SUBJECT: Negative Declaration for Radio Tower at Koloa, Kauai, TMK's 2-9-2:01 and 3-4-6:1

**FINAL  
ENVIRONMENTAL ASSESSMENT  
FOR  
PROPOSED RADIO TOWER  
CONSERVATION USE PERMIT APPLICATION**

**XII. RESPONSE TO COMMENTS OF DRAFT ENVIRONMENTAL ASSESSMENT**

EXHIBIT 1

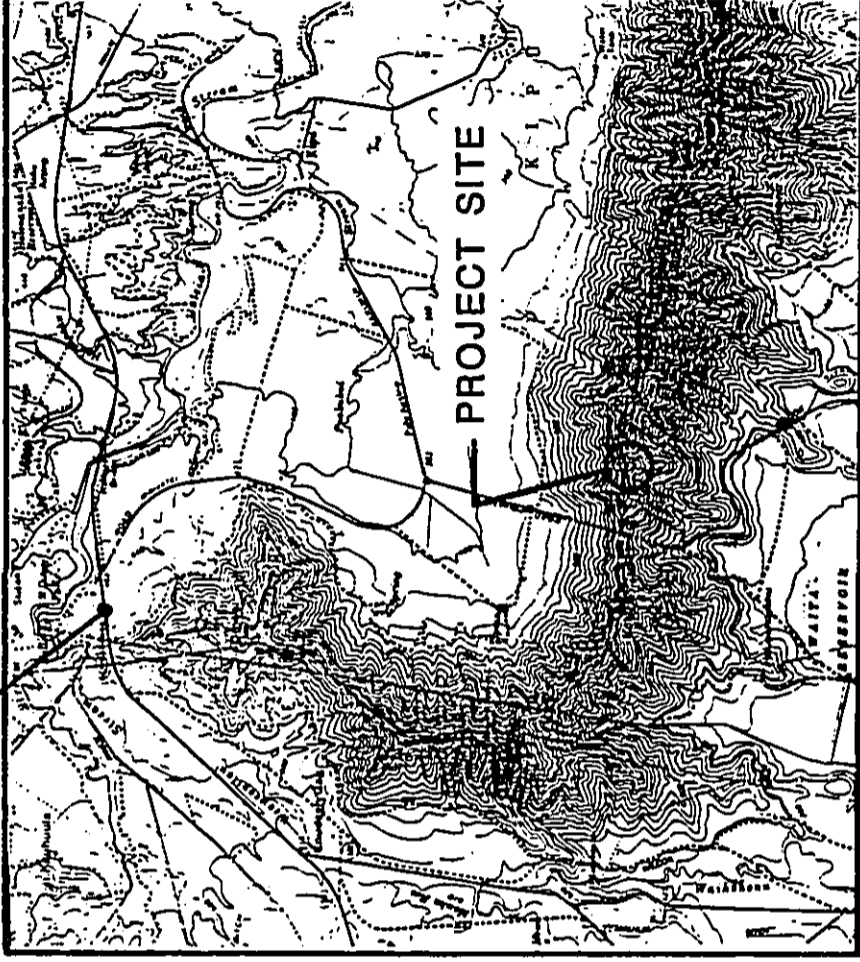
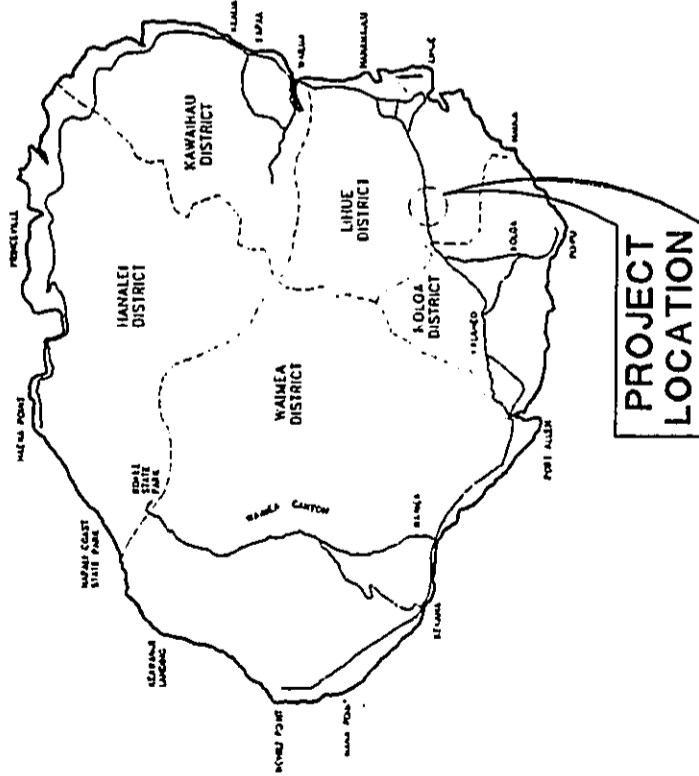
1. Exhibit 1 Location map clearly shows the project site to be on Kaunuaui Highway and in the Lihue judicial district. Please clarify the site's location in the text or correct Exhibit 1 if it is incorrect.
2. What tower is pictured in Exhibits 7 and 8?
3. Consult with government agencies, including the Kauai Planning Department, and any interested community groups or individuals and document your contacts.
4. Include a realistic timeline that takes into account the review and processing time for HRS Chapter 343, the Conservation District Use Permit and any other required permits. Please bear in mind that project activity cannot begin until all permits have been obtained.
5. Will any measures be incorporated in the design or installation of the tower to prevent hurricane damage?

- 1. Exhibit 1 Location map clearly shows the project site to be on Kaunuaui Highway and in the Lihue judicial district. Please clarify the site's location in the text or correct Exhibit 1 if it is incorrect. Portions of the project site being leased by Sianqi Broadcasting from Grove Farm actually straddle both the Koloa and Lihue district boundaries. However, the tower itself and most of the hardware will be located on the Koloa side. Please refer to Exhibit 1 for a graphic depiction.**
